BOSTON EDISON COMPANY  
GENERAL OFFICES 800 BOYLSTON STREET  
BOSTON, MASSACHUSETTS 02199

BECO. Ltr. #76-31

Docket No. 50-293  
License No. DPR-35

Additional Information Regarding  
Single Loop Operation Submittal

FIGURE 5-1 DECAY RATIO VERSUS POWER CURVE FOR TWO-LOOP AND SINGLE-LOOP OPERATION.

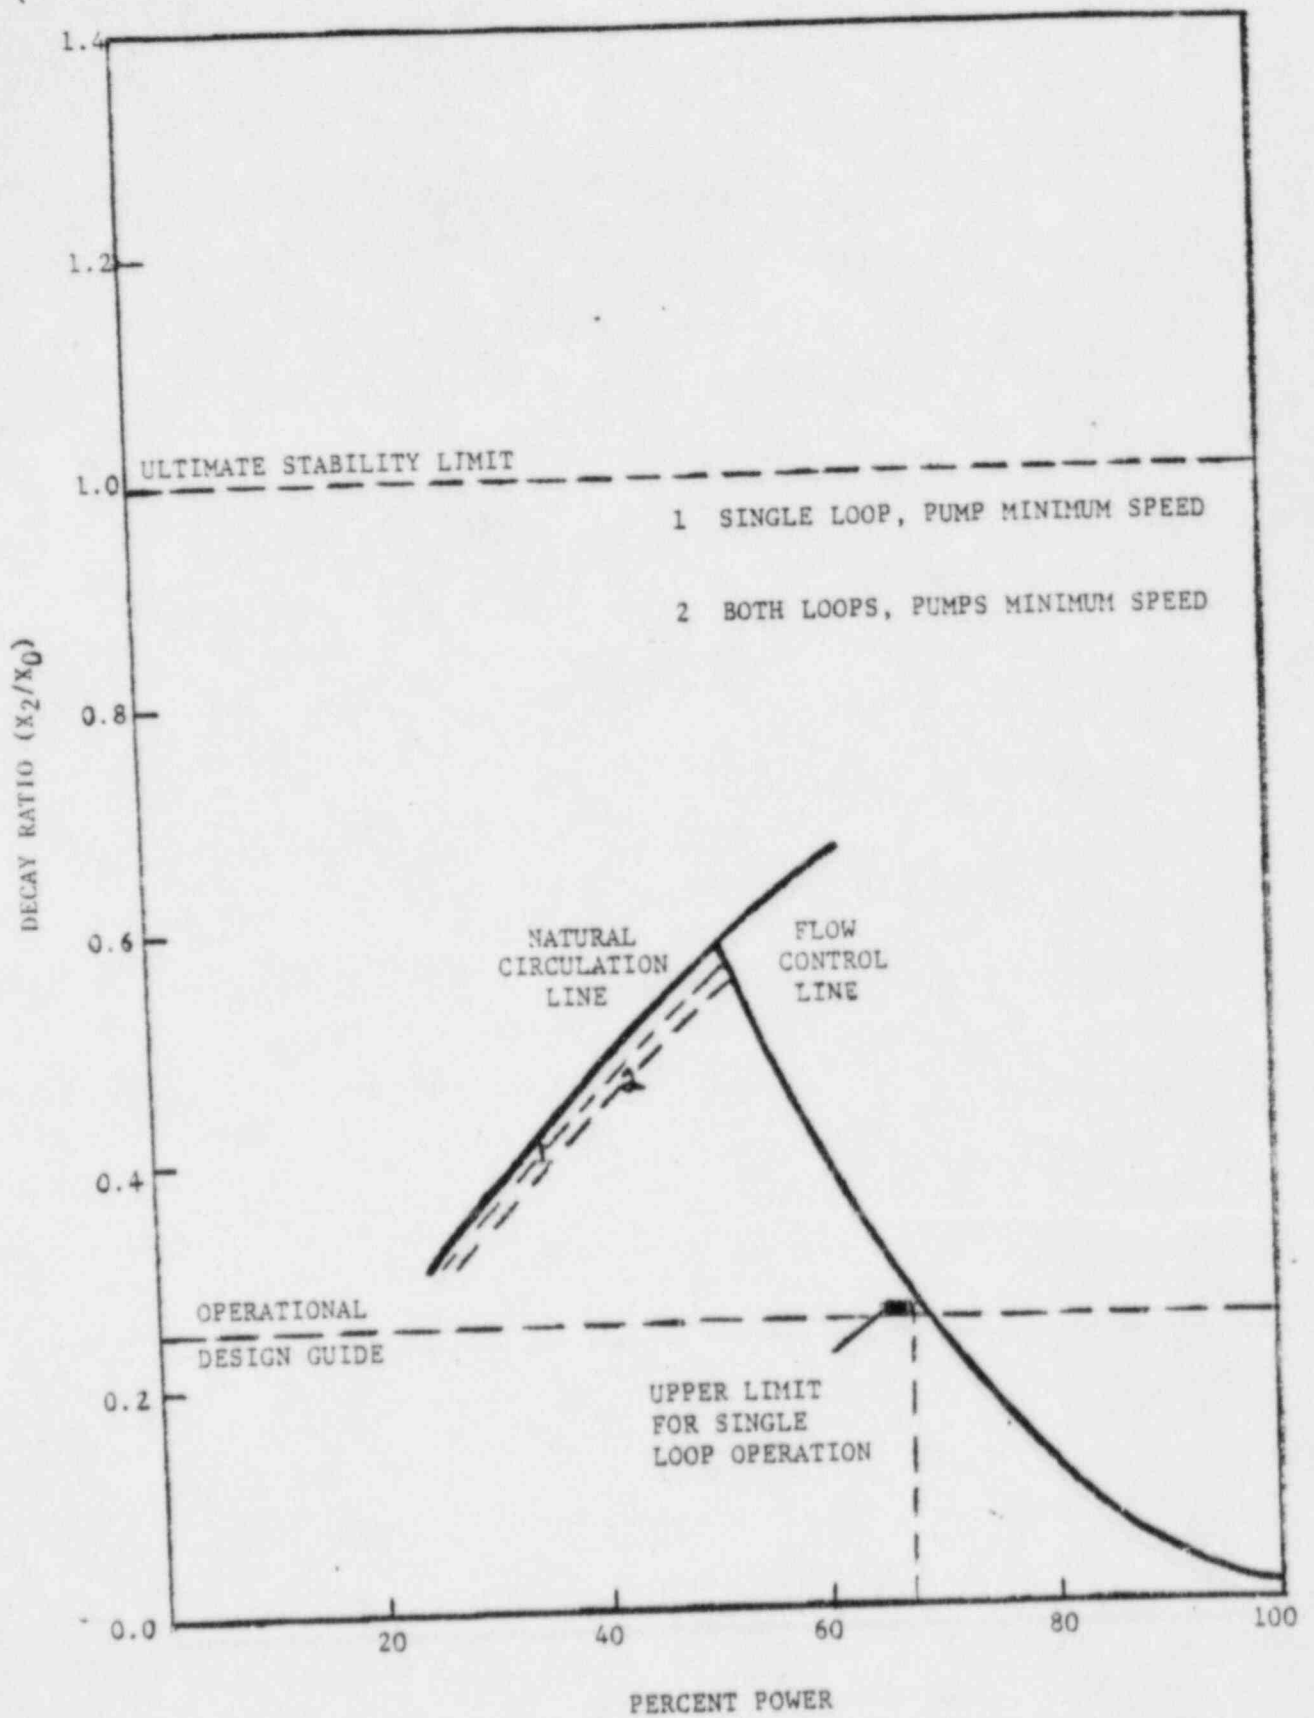
Question 1. The additional information on the stability analysis presented in Supplement 1 to NEDO-20999 is not clear. Provide a curve of Decay Ratio versus Power similar to NEDO-20855-01 Figure 7-19 for single loop operation.

Response 1. A rewrite of Section 5 is given below.

The least stable power/flow condition attainable under normal conditions occurs at natural circulation with the control rods set for rated power and flow. This condition may be reached following the trip of both recirculation pumps. Operation along the minimum forced recirculation line with one pump running at minimum speed is more stable than operating with natural circulation flow only, but is less stable than operating with both pumps operating at minimum speed. The core stability along the forced circulation, rated rod pattern line for single loop operation is the same as that for both loops operable except that rated power is not attainable. Hence, the core is limited to maximum power for single pump operation and only manual flow control should be used. This is illustrated in Figure 5-1.
